MEMORANDUM

FILE NO.: CSP2013 0007 & CSP2013 0010

PROPOSAL: Vacate three parking spaces in CBJ ROW along Front Street and four parking spaces in CBJ ROW along Seward Street.

Project: **Walter Soboleff Center, Sealaska Heritage Institute**
Subject: Street Parking Vacation
To: Rorie Watt, Engineering Director; Hal Hart, CCD Director
Cc: Lee Kadinger, SHI
From: Paul Voelckers
Date: April 3, 2013

1 REVISED PARKING; ADDITIVE ALTERNATE 2
 1" = 10'-0"

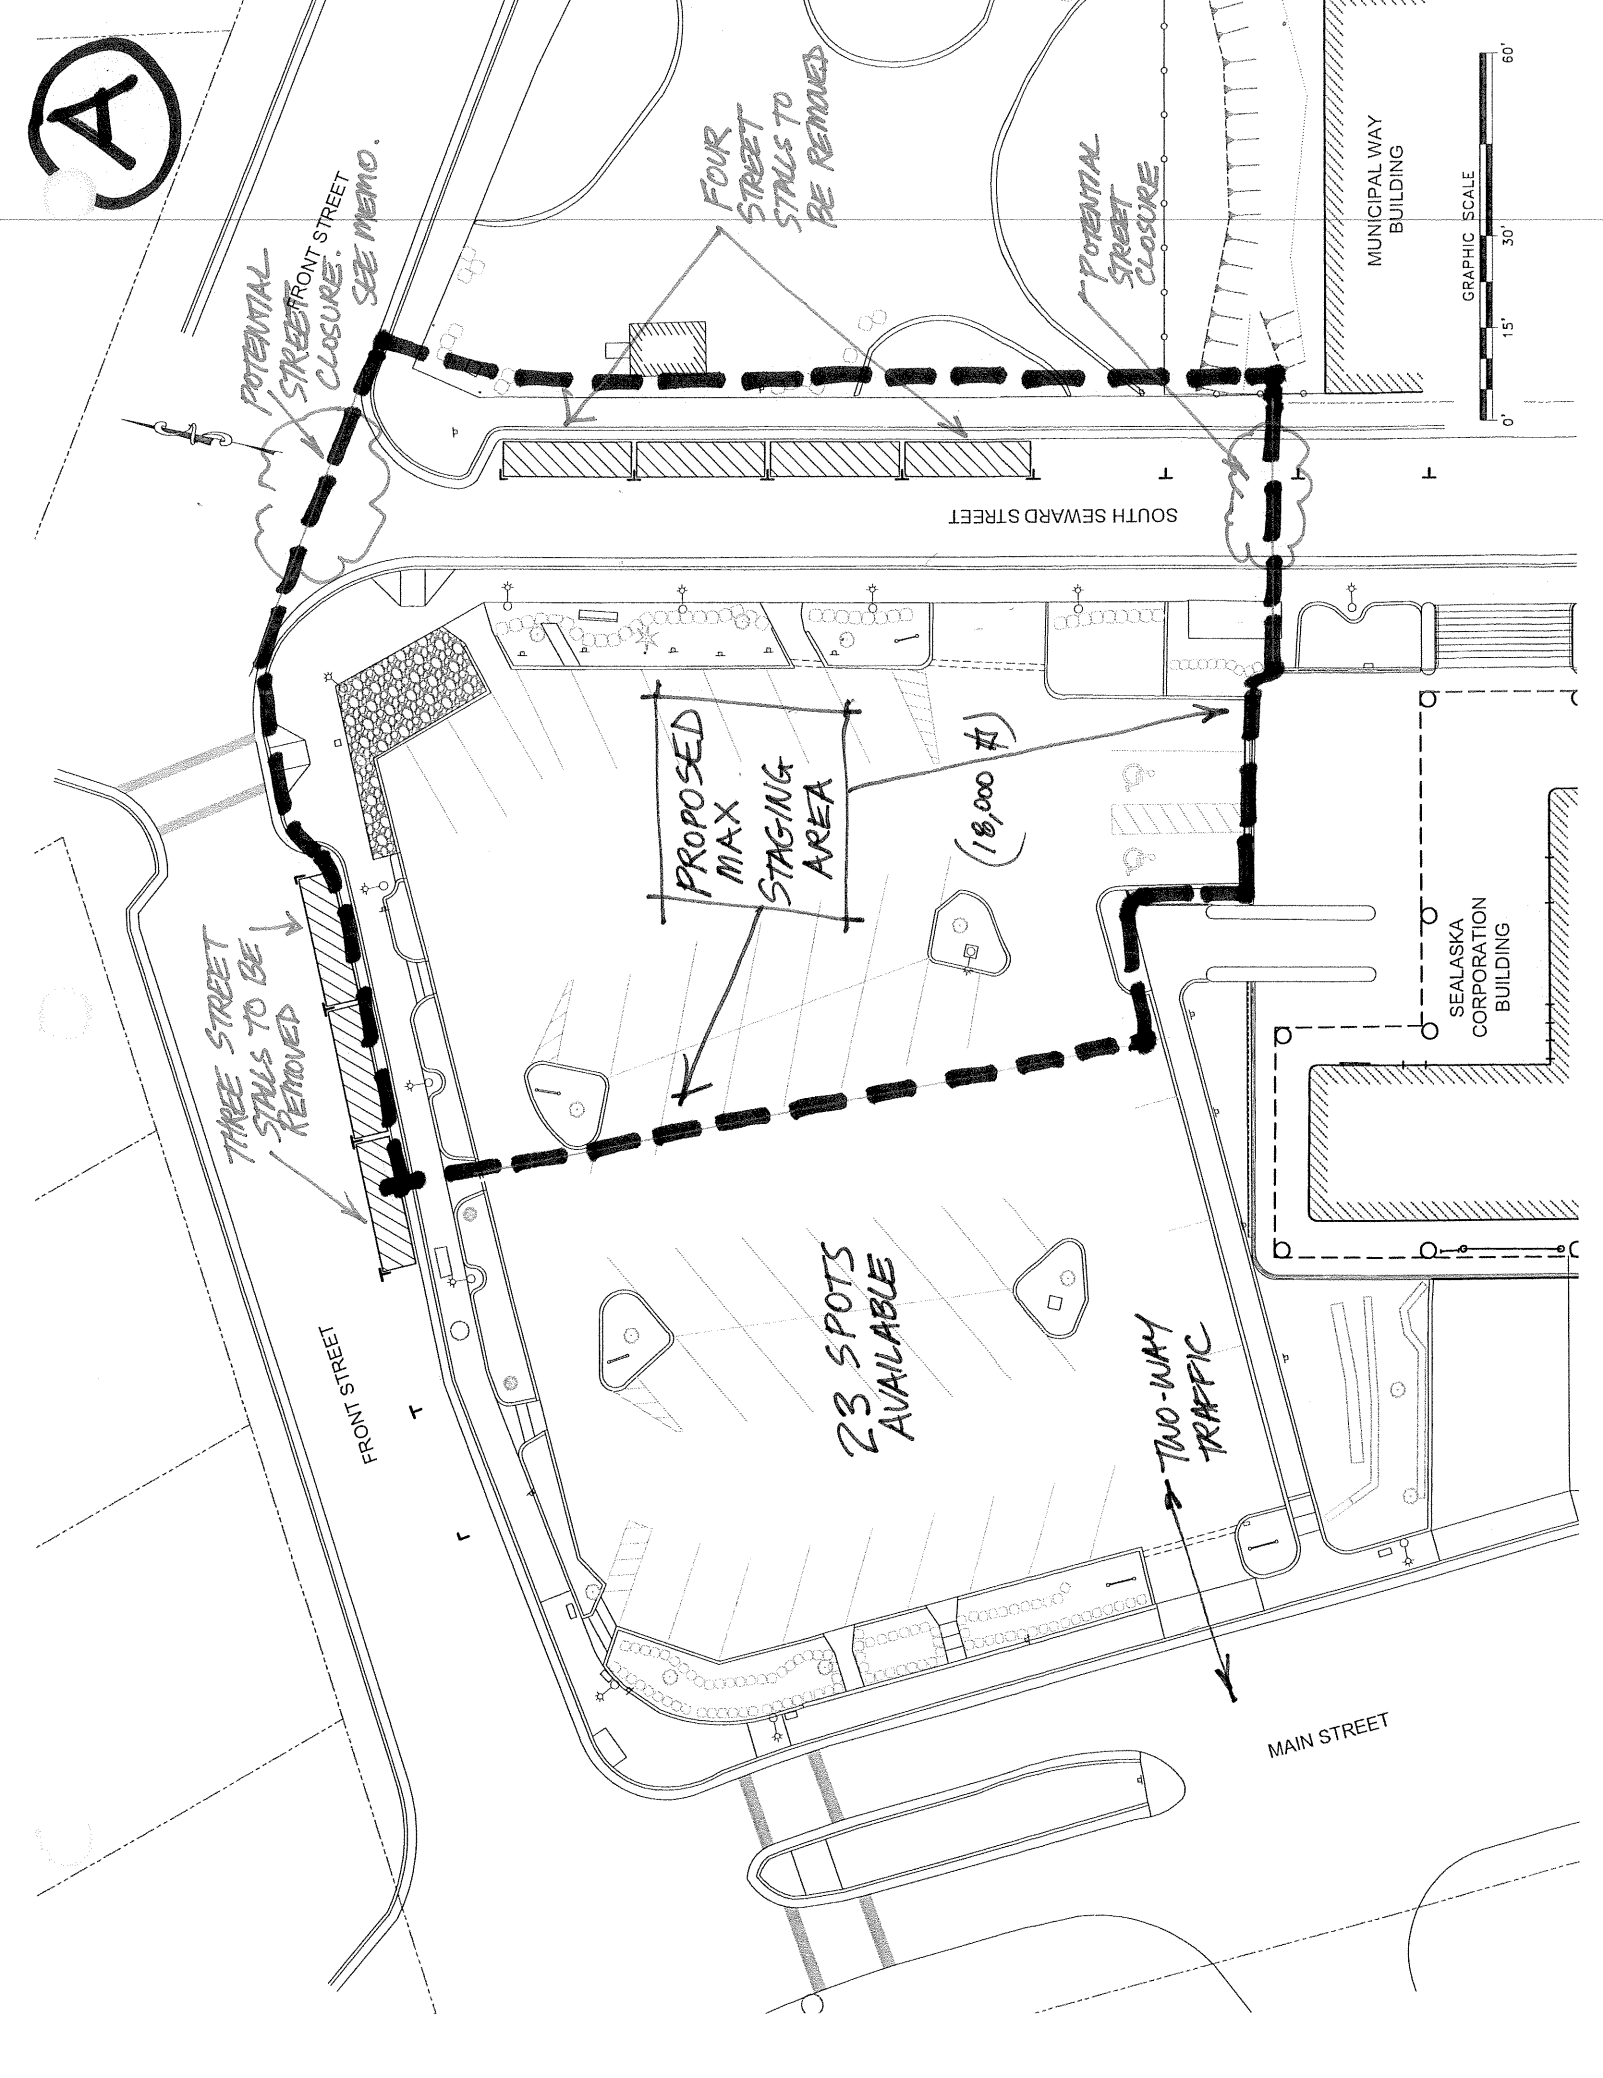
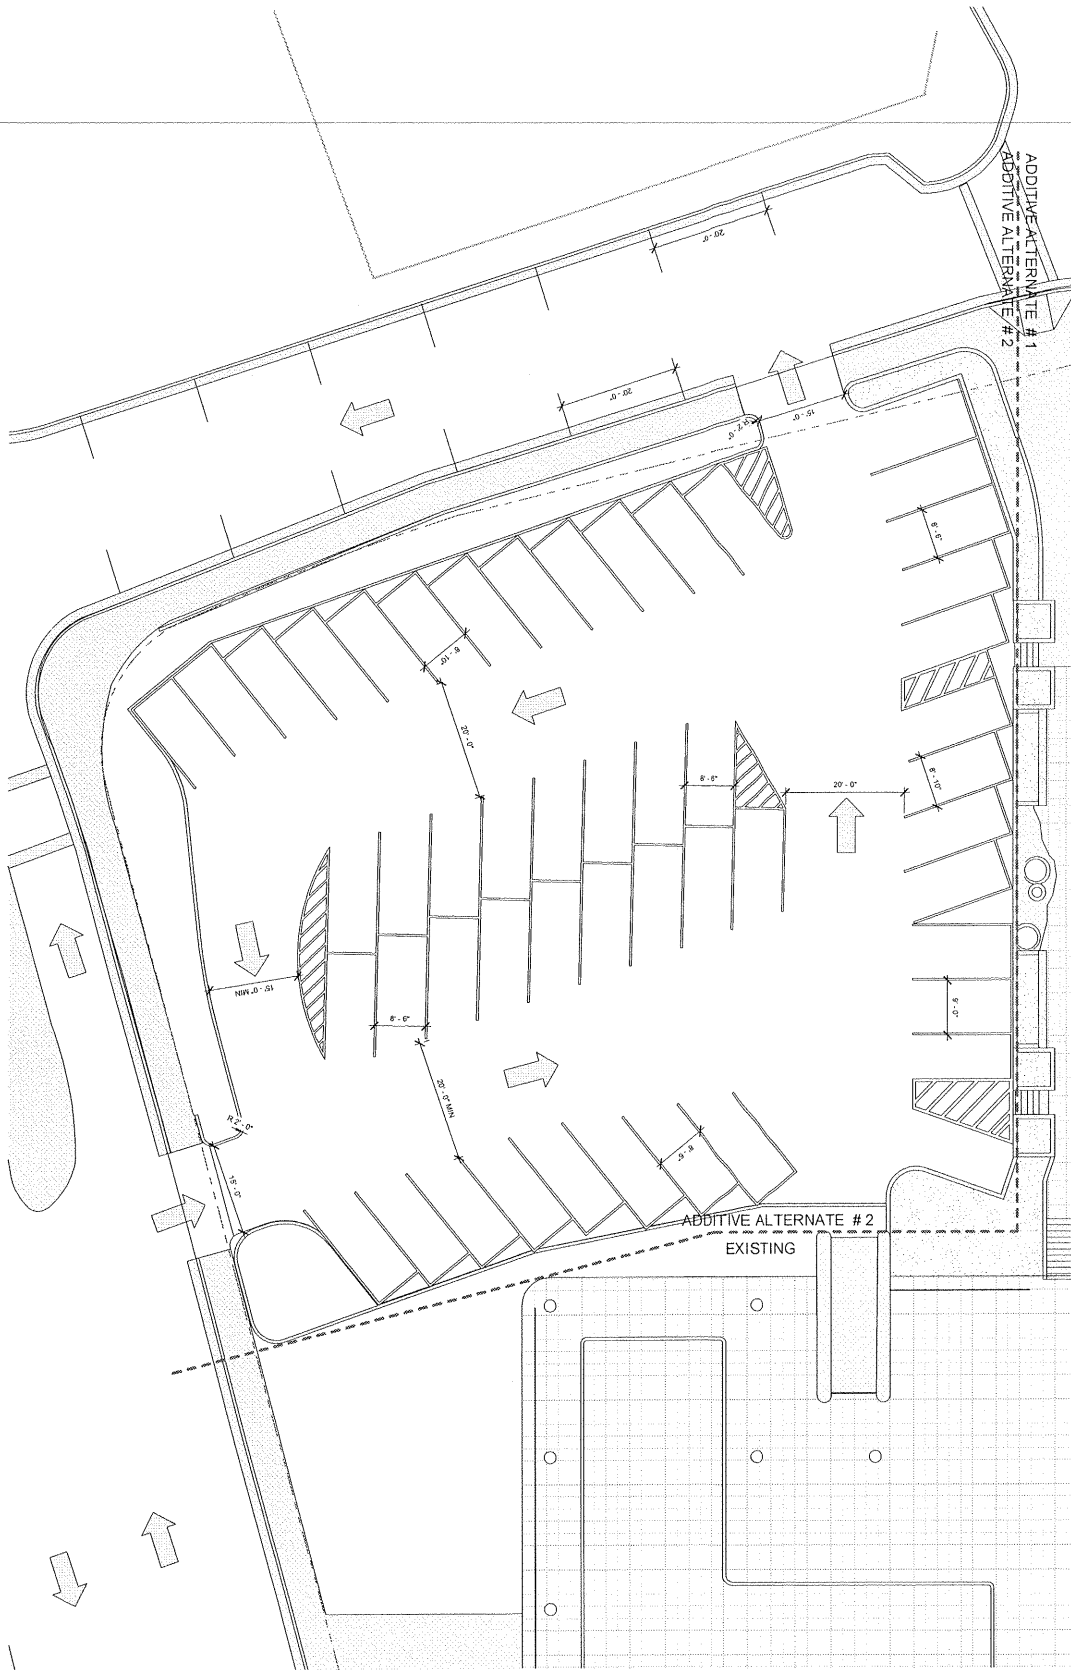
When this reconstruction occurs, the configuration of the parking lot will be altered and improved so that the discharge from the parking lot is to Front Street, not Seward Street. This allows for the expansion of pedestrian frontage on both sides of Seward Street. The vehicular exit to Front Street is also advantageous because it routes traffic back to Main Street, with more options for parking lot access and street routing. The exit route to Front Street requires the elimination of three stalls.

THREE STREET STALLS TO BE REMOVED

1 SITE PLAN
1/16" = 1'-0"

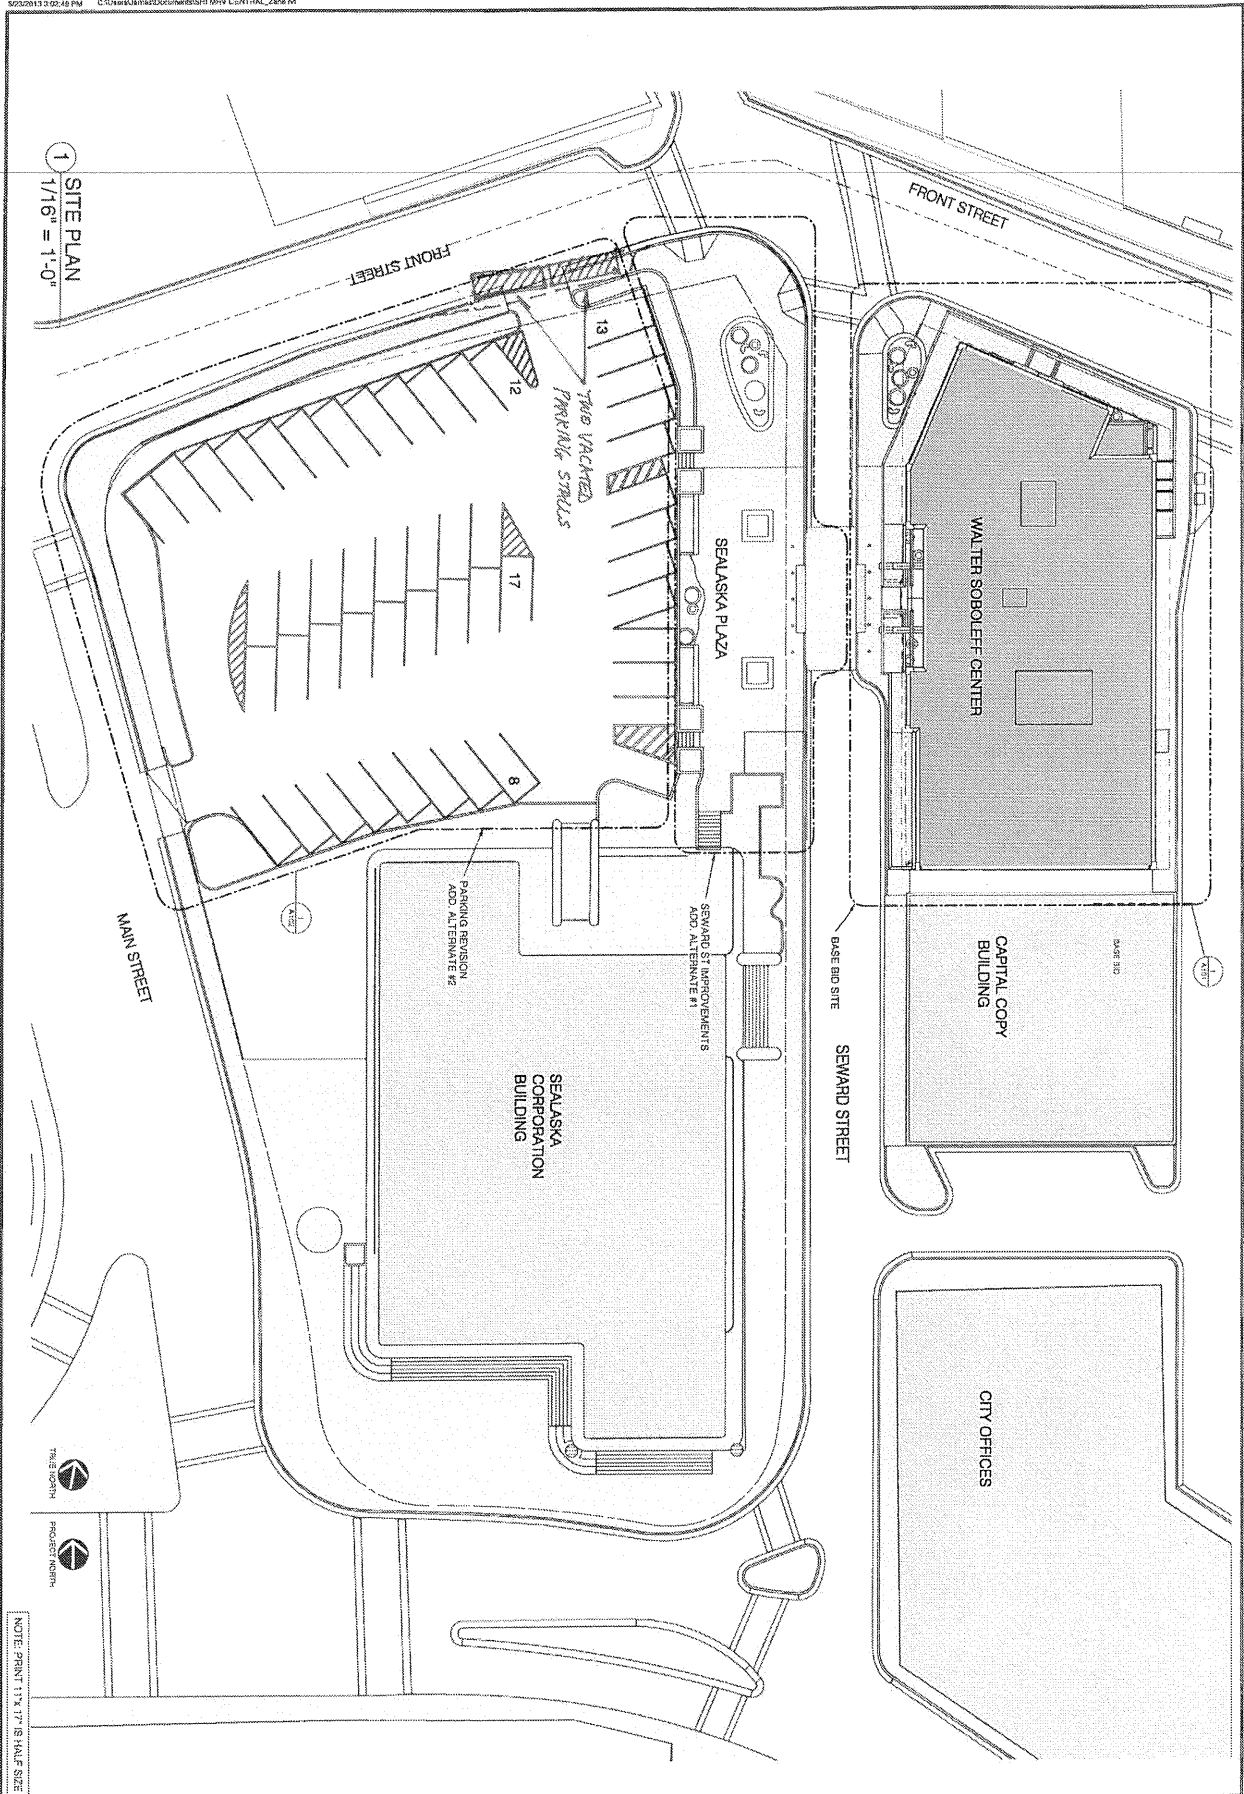
General Engineering objects to the closure of Seward Street. The blocking of Seward Street presents an issue of health and safety. Seward Street is critical to turning movements and fire department apparatus access. Also blocking the street eliminates the high use **LOADING ZONE** next to Copy Works as the access will be cut off. The sketch misrepresents the impact on parking.

Parking downtown is a premium and should not be removed. General Engineering objects to the removal of four parking stalls on Seward and the three stalls on Front St.

Parking vacation: Your drawing does not show an AELP utility lid/vault near the 3 stalls on front street for vacation. As long as the new design does not impact this lid/vault, I do not see any problems with vacating any of the 7 parking stalls from a utility perspective.
